HUITT-ZOLLARS

RE: Addison Circle Phase II
Public Infrastructure
HZI Project No. 01-1822-21

RE: Addison Circle Phase I Public Infrastructure
Revised Tree Well Planting in Roundabout
HZI Project No. 01-2013-01

TREE FENCE 
N.T.S.
EXHIBIT "C"

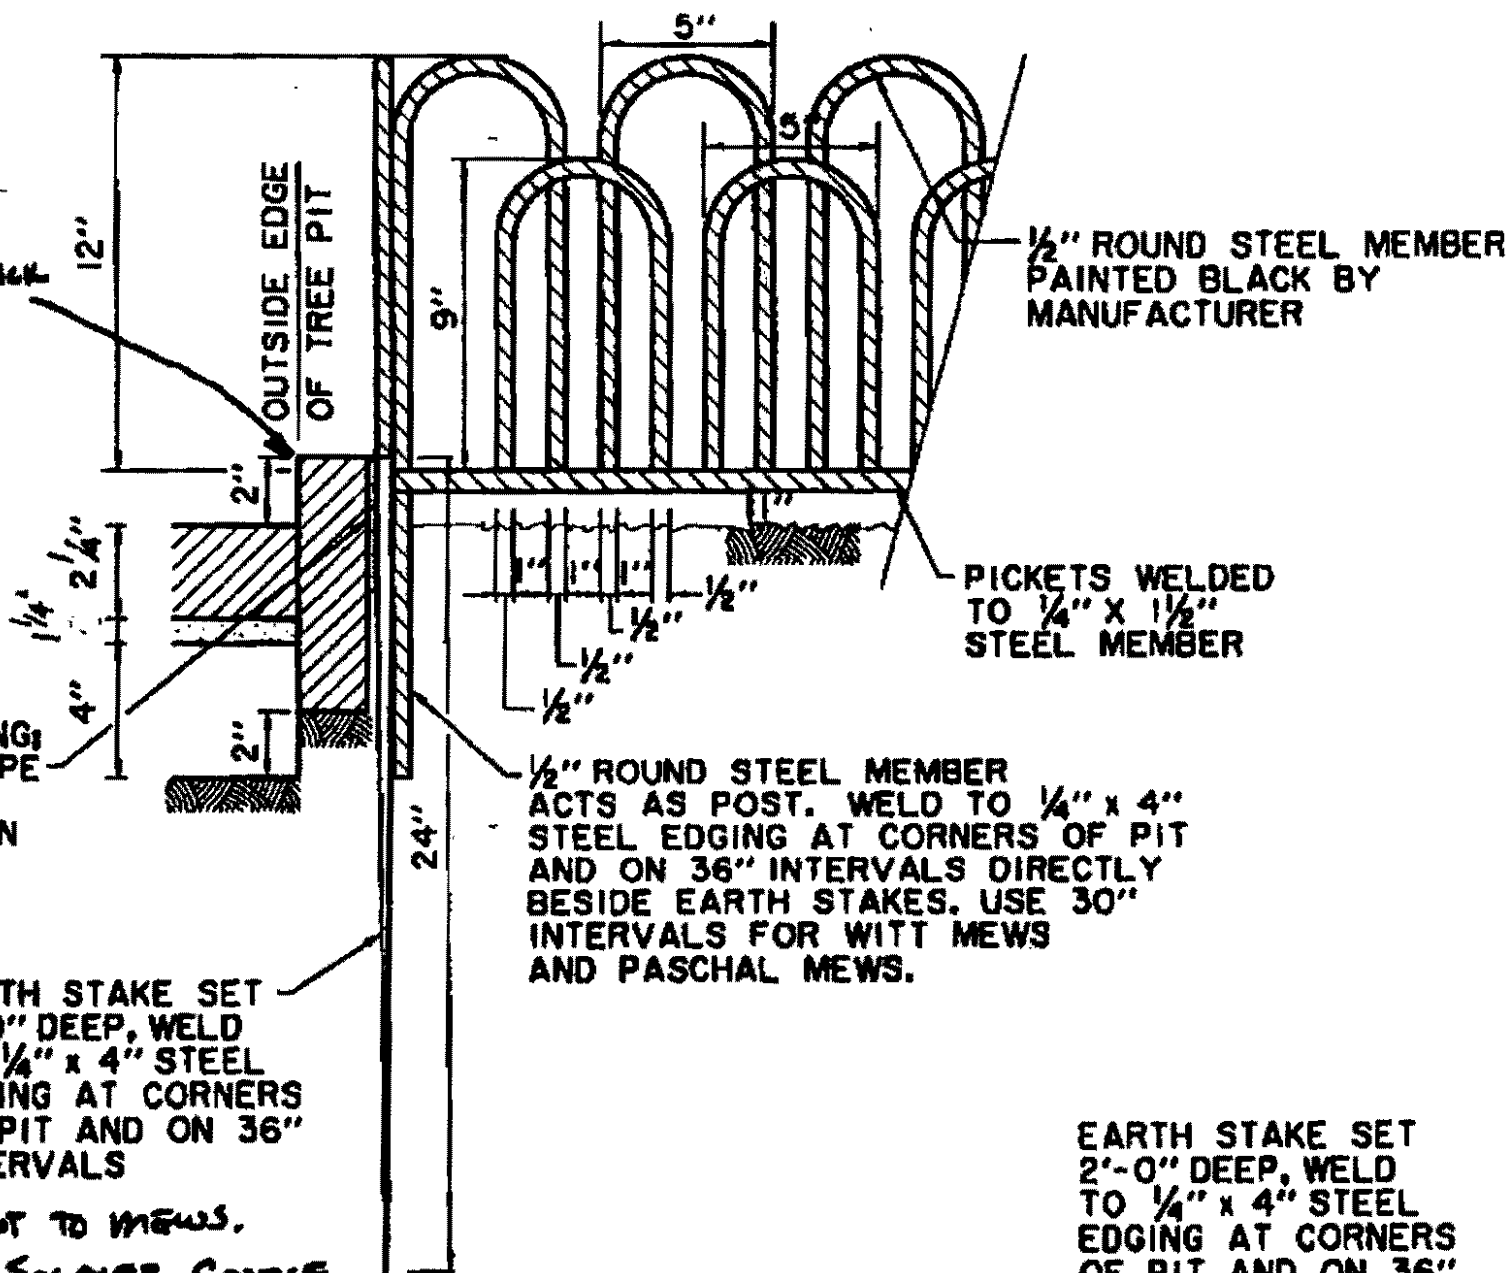
Exhibit "B" illustrates the extension of the sub-base under the soldier course in more detail. Please note that the soldier course brick must be cut from 8" in length to 5-1/2" to maintain 2" above the brick surface. Exhibit "C" illustrates that the soldier course adjacent to the Mews pavement must remain as designed since there is no practical way to dowel on a 2-1/4" piece of concrete to the existing street pavement for the support of the soldier course. All other sides of the tree pit in the mews can be constructed as shown in Exhibit "B".

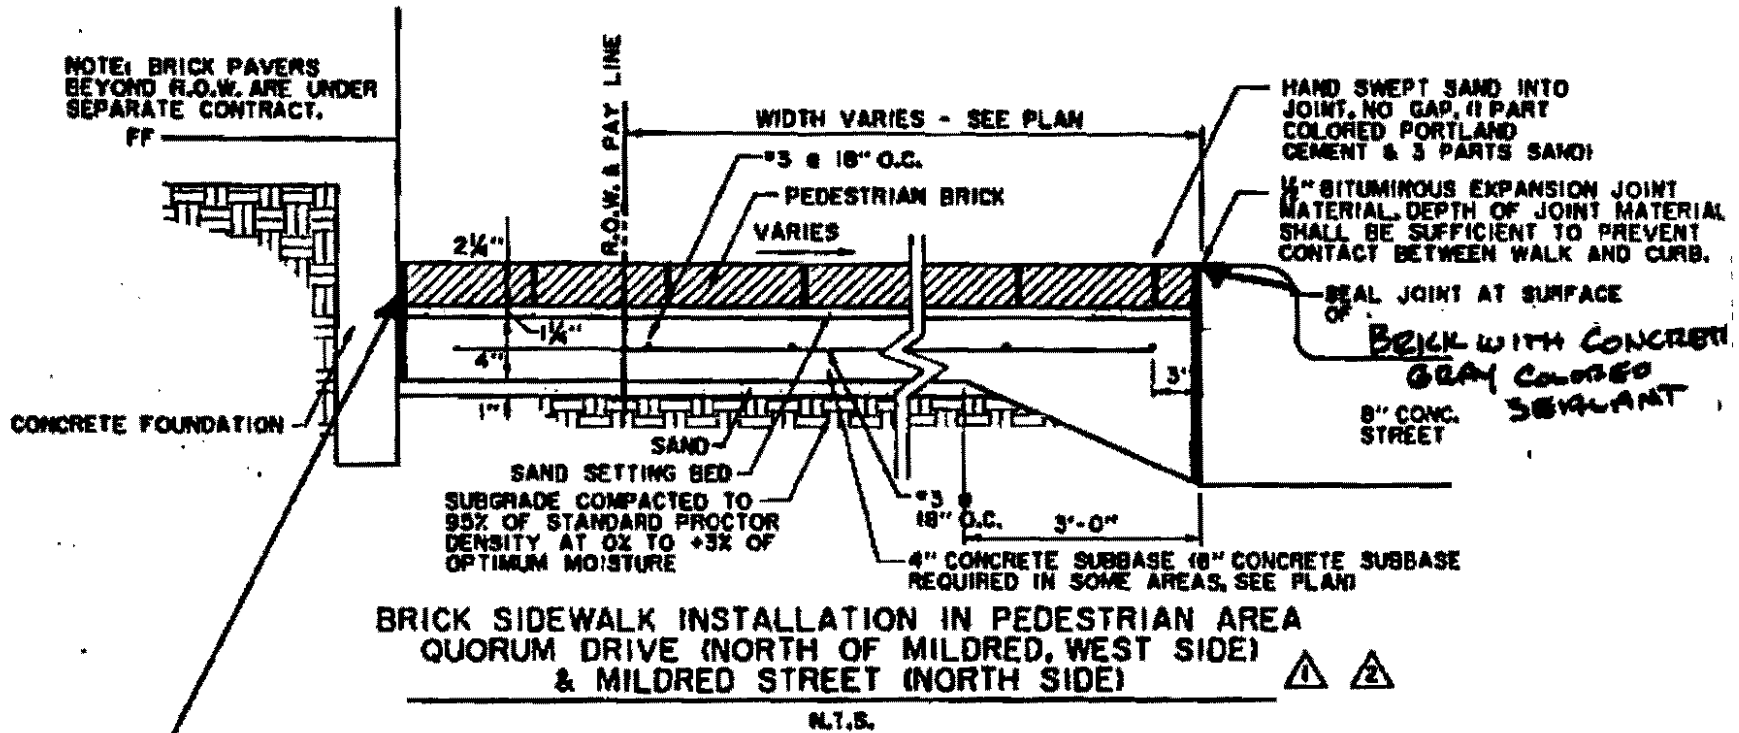
Exhibit "D" is to clarify what is required for expansion joints in the sidewalk with brick surfaces. There shall be an expansion joint between the sidewalk sub-base and the street pavement from the bottom of the sub-base to the top of curb at which point a concrete gray colored seal will be applied. There shall be an expansion joint adjacent to building foundations that will extend from the bottom of the sidewalk sub-base to the brick surface at which point the expansion joint will be sealed with a concrete gray colored sealant.

ADDISON CIRCLE STREET SIGNS

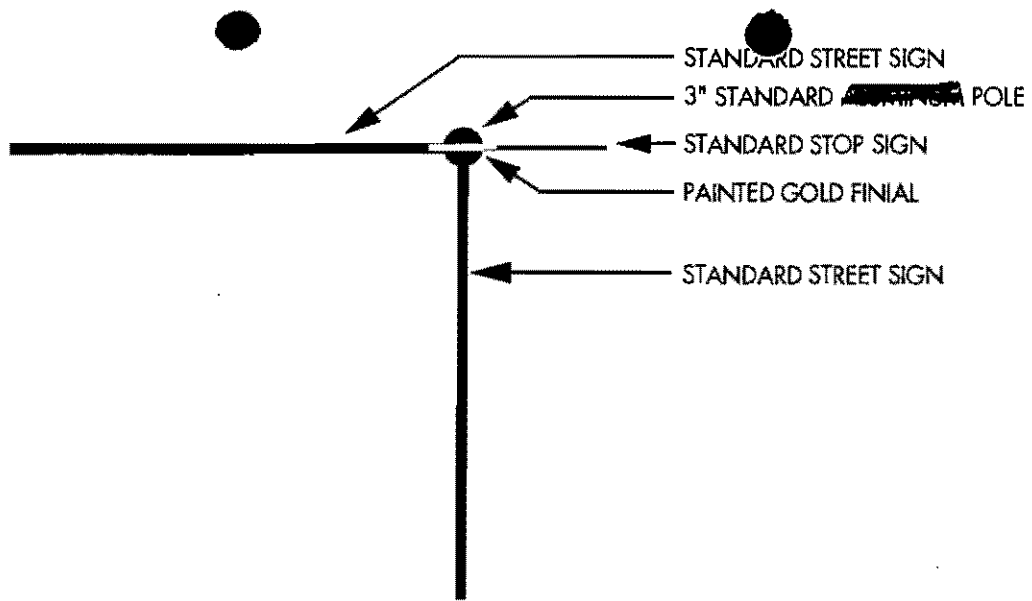
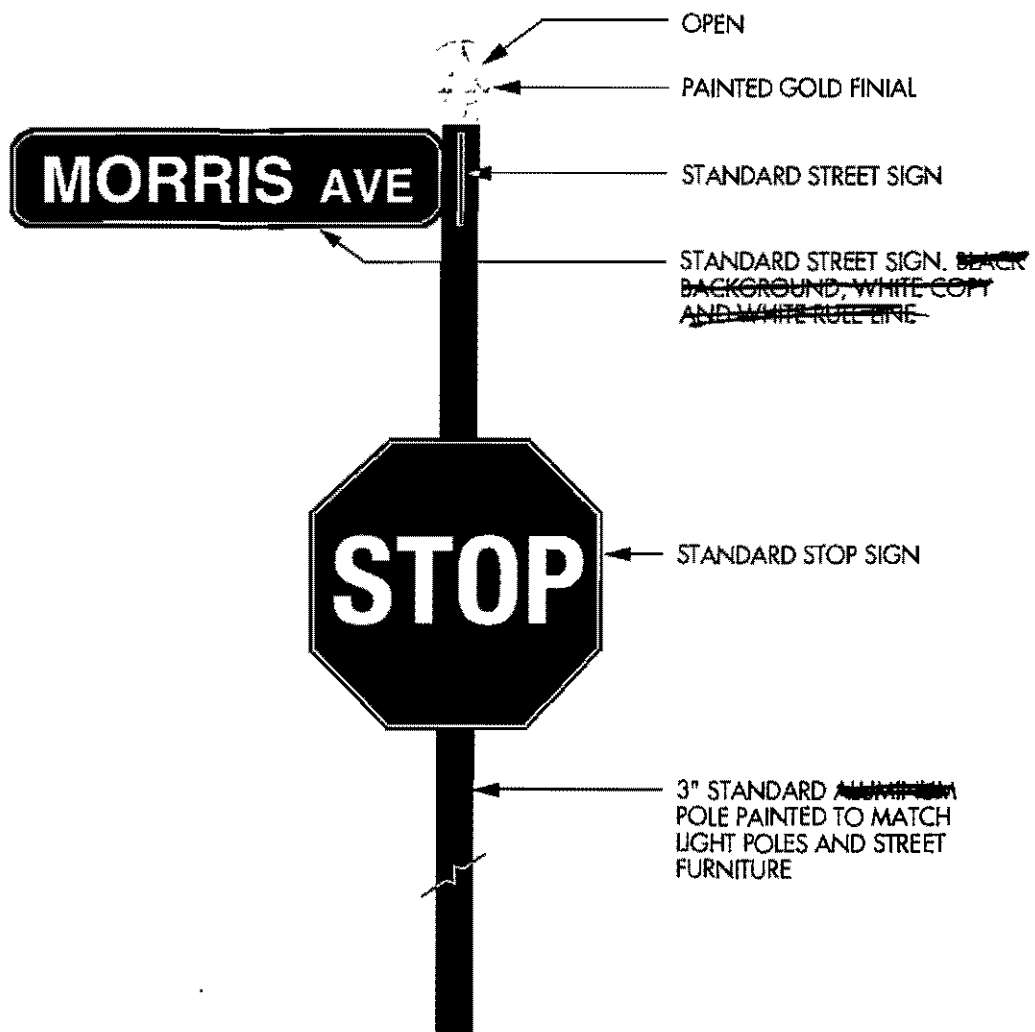
There are six locations on sheet 17 of the plans that we request the use of this alternate post and mounting hardware. If this alternate is acceptable, please provide us with the amount of extra posts, brackets and mounting hardware that will be required. We will have a meeting with Gibson & Associates to initiate a change order process upon notification of approval. If the alternate is not approved, we will release Gibson to order the necessary Uni-strut posts and hardware.

ADDISON CIRCLE STREET SIGNS

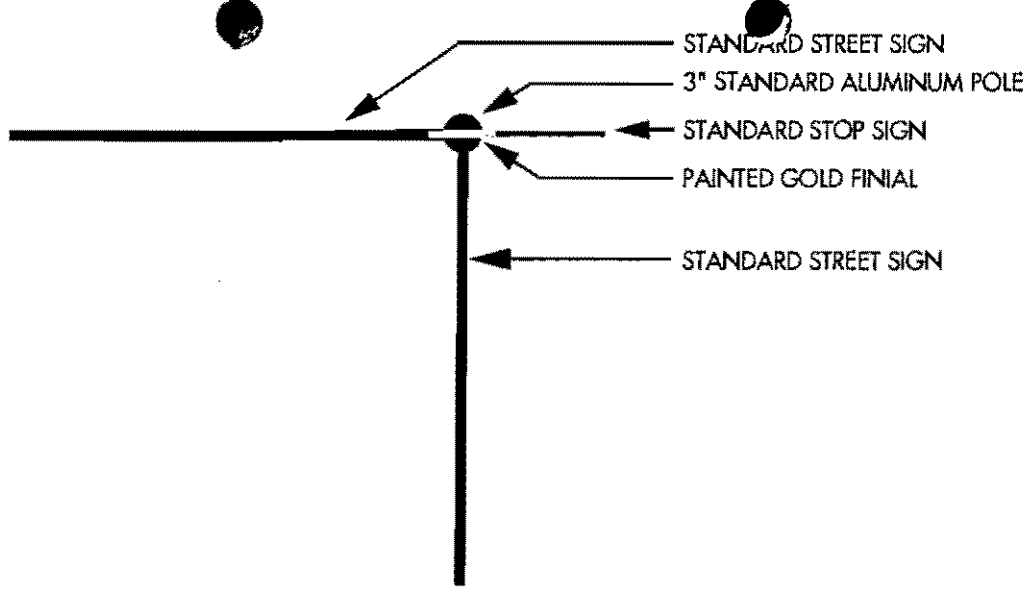
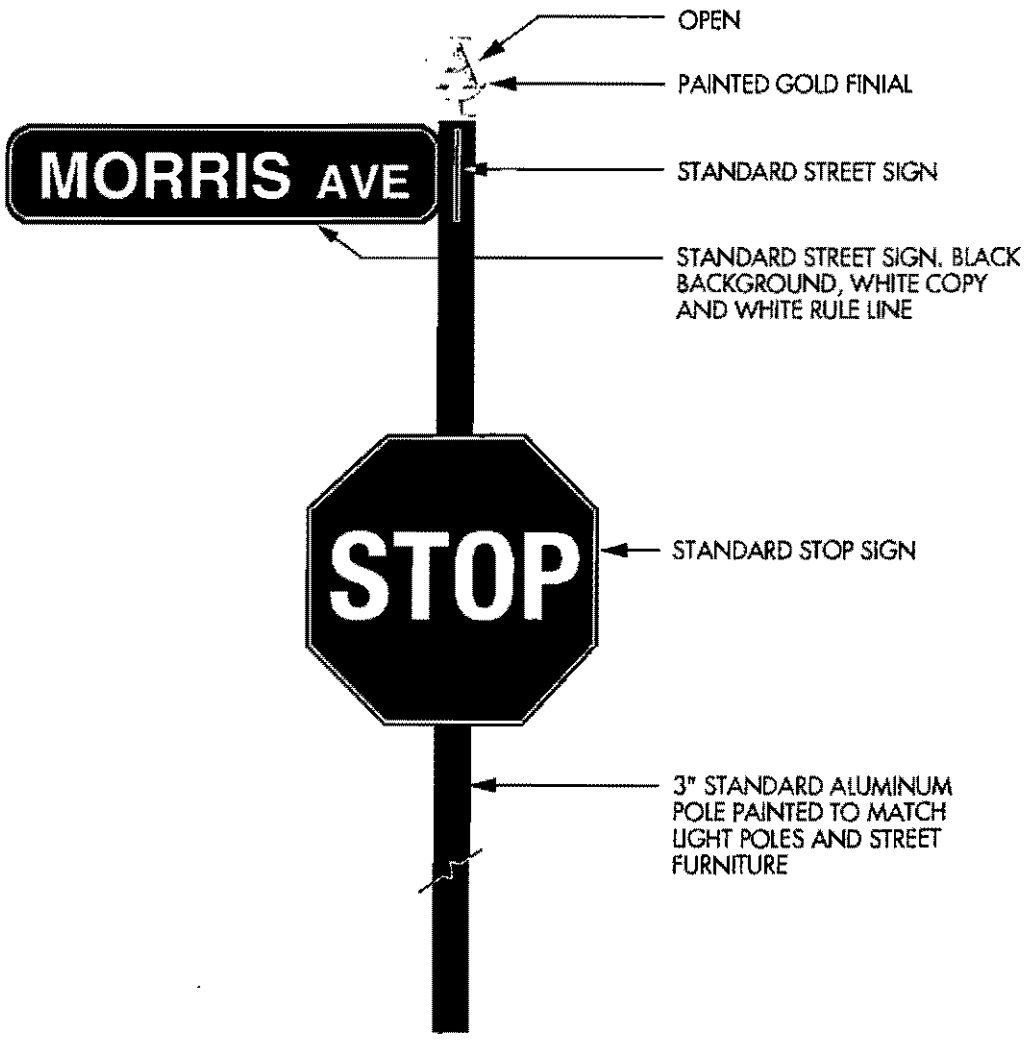
- we only need Two Quorum Drive Block Assignments

WE NEED A THIRD MORRIS AVE. BLOCK ASSIGNMENT

ADV-D1

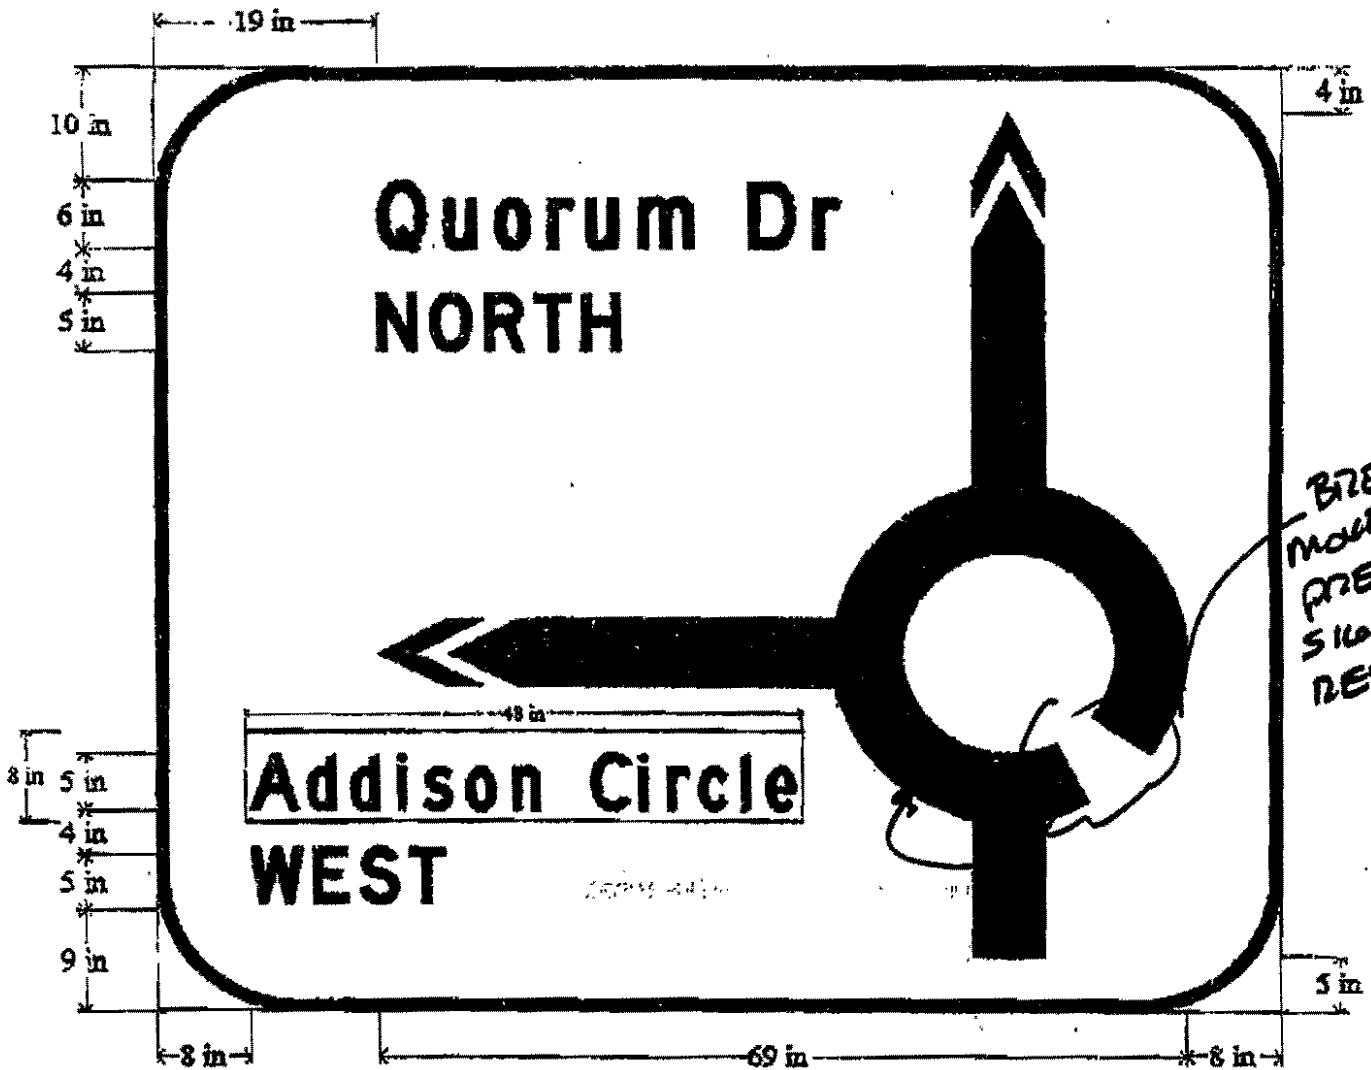
The Town of Addison has approved the name change of Mildred Street to Addison Circle. Please provide a change order price for field modifications to signs "ADV-D1", "ADV-D2" and ST-3. Each sign should be modified to read "Addison Circle" as noted on the following page.

LETTERING TO BE WHITE AS SPECIFIED ON ORIGINAL DRAWINGS.
